# Alt 1 NB and SB Left Turn Lanes

# Alt 1 Revisions Responding to Public Comments

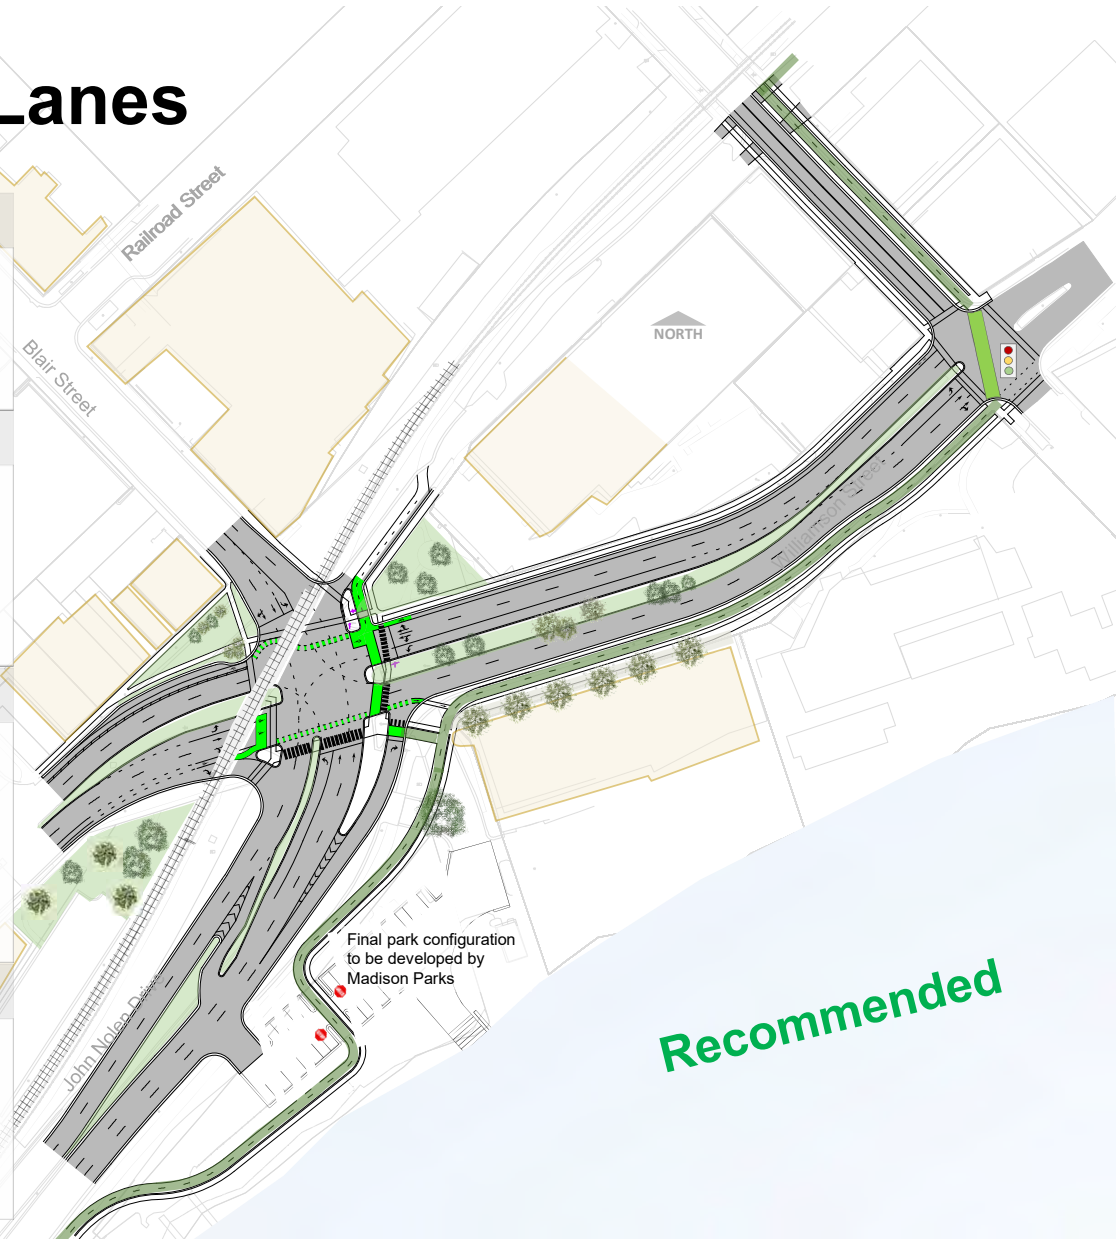
Greenspace in front of Hotel Ruby Marie is enlarged, yet loading zone/parking is maintained.

Connection to the Capital City Trail is improved by:

- Providing green epoxy guidance for cyclists through the intersection.
- Separating pedestrians and cyclists
- Providing better delineation for the Capital City trail along the alley way north of the Gateway center

Intersection is shifted to the west to make room for the NB and SB left turn lane.

Left turn lanes remove turning vehicles from through traffic stream

Median space is not reallocated to cycle track area in front of Machinery Road because it would eliminate median landscaping and potential for stormwater treatment.

NB to EB right turn radii is tightened to reduce travel speeds. Channelization remains due to high number of right-turning vehicles (~870 in the PM peak) requiring signal time during westbound left-turn, and the need for vehicle storage space separate from through traffic.

Staging area added for pedestrians and cyclists to keep them from blocking the Capital City Trail

NB to EB porkchop island is maintained and enlarged to:

- Separate the right-turning vehicle vs pedestrian movements
- Provide a larger refuge for bicycles and pedestrians.

Park configuration to be developed by Madison Parks

Island provided to:

- Provide refuge for pedestrians.
- Provide space for signage or signalization.
- Prevent left turns out of parking lot.
